## 2.0 SITE CHARACTERISTICS

The applicant addressed the PSEG Site location and description in Site Safety Analysis Report (SSAR) Section 2.1.1, "Site Location and Description" of the Early Site Permit (ESP) application, in which the applicant provided site-specific information related to site location and description, including political subdivisions, natural and manmade features, population, highways, railways, waterways, and other significant features of the area. In SSAR Figure 1.2-1, "PSEG Site Location—6-Mile Radius," and SSAR Figure 1.2-2, "PSEG Site Location—50-Mile Radius," the applicant showed the PSEG Site location and the surrounding area within 9.6 kilometers (km) (6 miles (mi)) and 80 km (50 mi), respectively, and identified the prominent natural and manmade features, including the Delaware River, towns, and major transportation routes.

**Figure 2.3-8 Site Utilization Plan (Reproduced from SSAR Figure 1.2-3)**

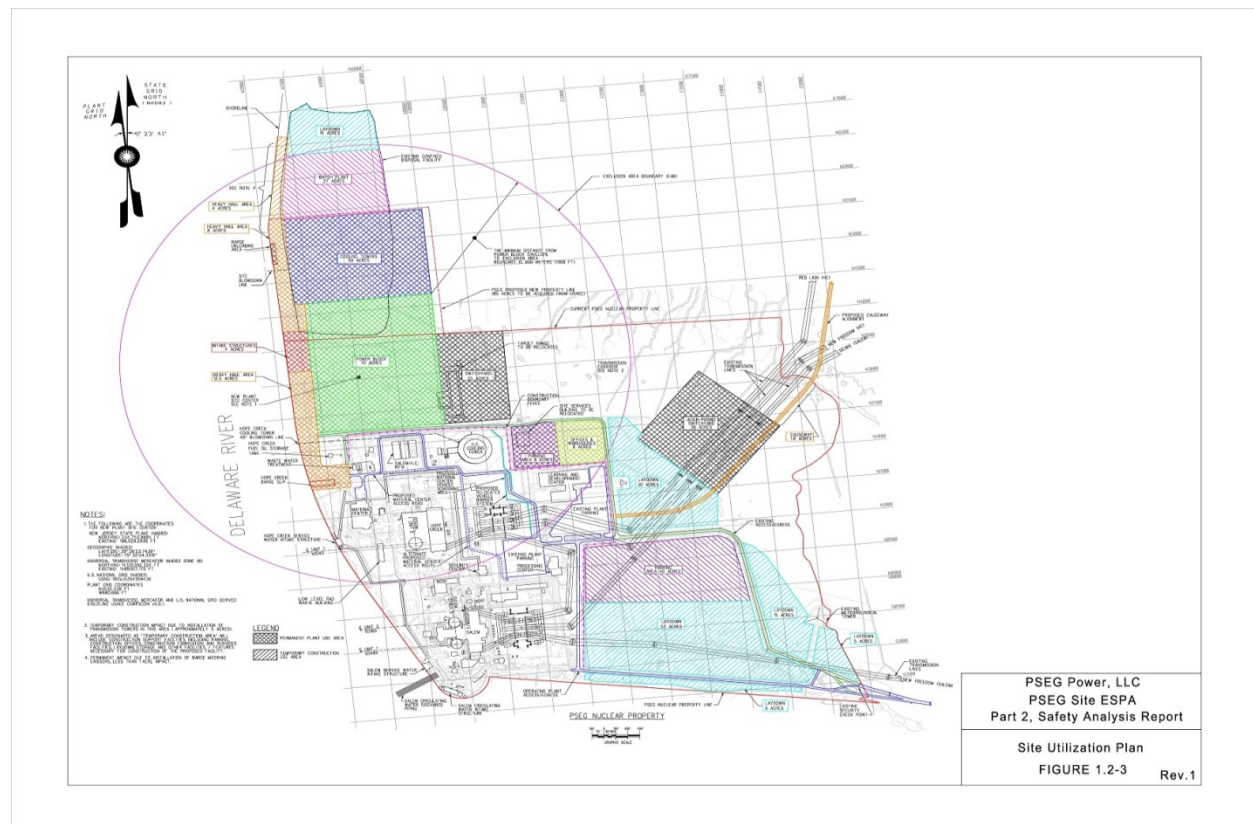
Coordinates for the power block reference point are provided in geodetic and UTM systems. SSAR Section 2.1.1.2 (Paragraph 2) and SSAR Figure 1.2–3 identified the UTM coordinates without units, which appear to be measured in feet. Therefore, in RAI 9, Question 02.01.01-1, the staff requested that the applicant annotate the list of UTM coordinates in the SSAR and to do so in the marginal notes on SSAR Figure 1.2-3 with the correct units of measure. In a March 21, 2011, response to RAI 9, Question 02.01.01-1, the applicant provided a revision to

The PSEG proposed Exclusion Area Boundary (EAB) is a circle at least 600 m (1968 ft) from the edge of the power block area in all directions as shown in SSAR Figure 1.2-3. As shown in SSAR Figure 2.1-23, the proposed EAB extends beyond the PSEG Site property line to west (into the Delaware River) and to the north and northeast. The total area that the EAB encompasses is 3.0 km<sup>2</sup> (743 acres), of which 0.91 km<sup>2</sup> (224 acres) is in the Delaware River and 1.17 km<sup>2</sup> (288 acres) is in land that PSEG currently owns. PSEG will own an additional 0.344 km<sup>2</sup> (85 acres) of land when it completes property acquisition with the USACE. The land within the EAB that PSEG does not own consists of 0.59 km<sup>2</sup> (146 acres), which the Federal Government owns. No public roads, railroads, or structures other than the existing PSEG power plant facilities are located within any part of the EAB. From the information in SSAR Section 2.1.1.2 and SSAR Figure 1.2-3, it appears to the staff that the additional 0.344 km<sup>2</sup> (85 acres) of land is bounded by the area, as described in "PSEG Proposed New Property Line." In RAI 9, Question 02.01.01-2, the staff requested that the applicant distinguish the different areas in EAB and clarify them in SSAR Section 2.1.1.2 and SSAR Figure 1.2-3 accordingly. In a March 21, 2011, response to RAI 9, Question 02.01.01-2, the applicant provided clarification along with proposed revisions to SSAR Section 2.1.1.2 and SSAR Figure 1.2-3. The staff reviewed the response and found the applicant's clarification appropriate and adequate, and therefore acceptable. The staff also confirmed the inclusion of the proposed revisions in SSAR Section 2.1.1.2 and SSAR Figure 1.2-3, Revision 1, submitted on May 21, 2012. Accordingly, the staff considers RAI 9, Question 02.01.01-2, resolved.

The land boundary, on which technical specification limits for release of gaseous radioactive effluents are based, is the PSEG Site property line shown in SSAR Figure 1.2-3. The minimum distance from the center point to the property line is 265.8 m (872 ft) in the west direction. The staff notes this suggests that it is one of the site boundary receptor locations being considered for dose evaluation. However, in a September 9, 2011, response to RAI 35, Question 02.03.05-04 (on SSAR Section 2.3.5, "Long-Term Atmospheric Dispersion Estimates for Routine Releases"), the applicant stated that although X/Q and D/Q values have been calculated for all 16 radial directions at the PSEG Site boundary including the PSEG Site boundary location receptor addressed above at 265.8 m (872 ft) in the west direction, sectors adjacent to the Delaware River (sectors SE to NW in clockwise direction) are not considered in the dose evaluations. Therefore, in follow up RAI 49, Question 02.01.01-3, the staff requested that the applicant update the information in SSAR Section 2.1.1.3 for clarity and consistency. In a February 24, 2012, response, the applicant provided information clarifying and justifying

The staff reviewed the site area map in the SSAR (Figure 1.2-3) for the proposed PSEG Site to verify that the distance from the proposed power block to the boundary line of the exclusion area meets the guidance in NUREG-0800, Section 2.1.1. Based on its review of the information in the SSAR, and confirmatory review of prominent, natural, and manmade features of the area as found in publicly available documentation, the staff finds the information provided by the applicant with regard to the PSEG Site location and description adequate and acceptable.

SSAR text in Section 2.1.1.2 and SSAR Figure 1.2-3 with the English unit of measurement (in feet), and committed to revise the SSAR with this information. The staff reviewed the applicant's response and subsequently confirmed that SSAR Revision 1, submitted on May 21, 2012, contained the information as committed in the RAI response. Accordingly, the staff finds the applicant's response acceptable and considers RAI 9, Question 02.01.01-1, resolved.

why sectors adjacent to the Delaware River are not considered in the dose evaluations. The applicant also committed to revise SSAR Section 2.1.1.3 with this information. The applicant specifically stated in the February 24, 2012, response to RAI 49, Question 02.01.01-3, that the X/Q and D/Q values (SSAR Table 2.3-37) at the PSEG Site boundary, adjacent to the Delaware River (sectors SE to NW in clockwise direction), are not considered in the associated analyses for radiological exposure from routine gaseous effluents, and that excluding the area adjacent to the Delaware River is acceptable because of the negligible time any individual is expected to spend in this area during any one-year period. The applicant further stated that the X/Q and D/Q values considered in the associated analyses for radiological exposure due to the routine gaseous effluents are those in sectors NNW to ESE (clockwise direction). The staff reviewed the applicant's response, clarification, and conclusion that doses resulting from radiological exposure will be negligible based on short-term presence of individuals in this area during any one-year period. The staff finds the applicant's clarification appropriate and adequate, and therefore acceptable. The staff also confirmed the inclusion of the proposed revision in SSAR Section 2.1.1.3, Revision 1, submitted on May 21, 2012. Accordingly, the staff considers RAI 49, Question 02.01.01-3, resolved.

**Figure 2.4.6-1 Major faults in the Greater Antilles region**

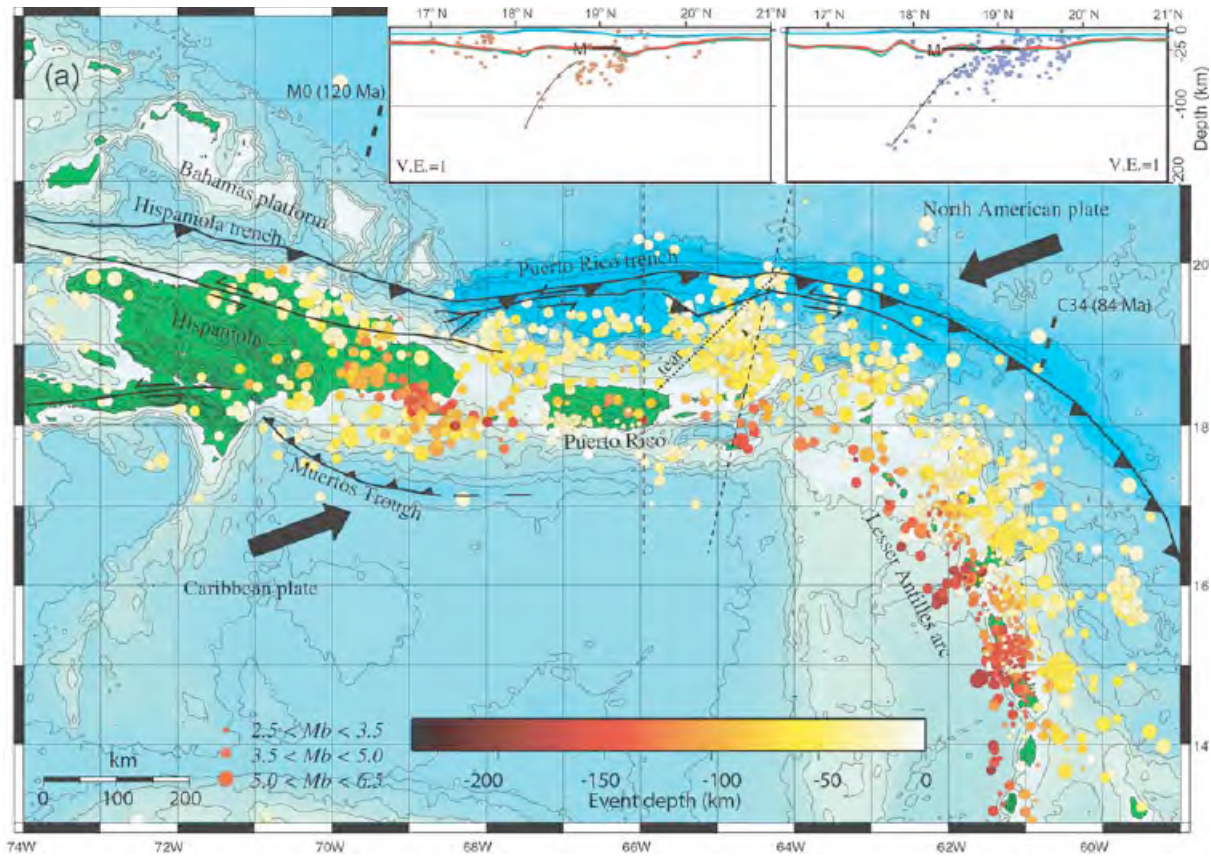
In RAI 20, Question 02.04.06-2, the staff requested that the applicant provide an updated figure showing a maximum slope angle of 0.3 degrees and an updated figure/reference to related work in SSAR Section 2.5.5 in a revision of the SSAR. In a May 11, 2011, response to RAI 20, Question 02.04.06-2, the applicant stated that SSAR Figure 2.4.6-1 has a scale of slope (i.e., dimensionless rise over run) ranging from 0 to 0.002. At the maximum scale value, the angle of the slope would equal 0.115 degrees. To minimize any further confusion over this figure, the applicant revised the figure to have a dimensioned scale in angular degrees. The staff verified that Revision 1 of the ESP application (May 21, 2012) contains the applicant's committed change.

Figure 2.4.6-1 shows the naturally occurring angular topography slopes on a grid in the vicinity of the PSEG Site, and shows a maximum slope value of  $0.3^{\circ}$  occurring inland of the site. Stability analysis will be conducted during the COLA phase of the project, and will include consideration of failure surfaces that extend into the Delaware River adjacent to the site as discussed in SSAR Subsection 2.5.5.1.

SSAR Figure 2.4.6-1, provided in Enclosure 3 of the applicant's May 11, 2011, response to RAI 20, Question 02.04.06-2, was revised by the applicant and submitted in a May 31, 2011, supplement to the May 11, 2011, response. The applicant committed to revise the SSAR to provide a scale in angular degrees. The staff confirmed that Revision 1 of the ESP application (May 21, 2012) contains the applicant's committed changes. Accordingly, the staff considers RAI 20, Question 02.04.06-2 resolved.
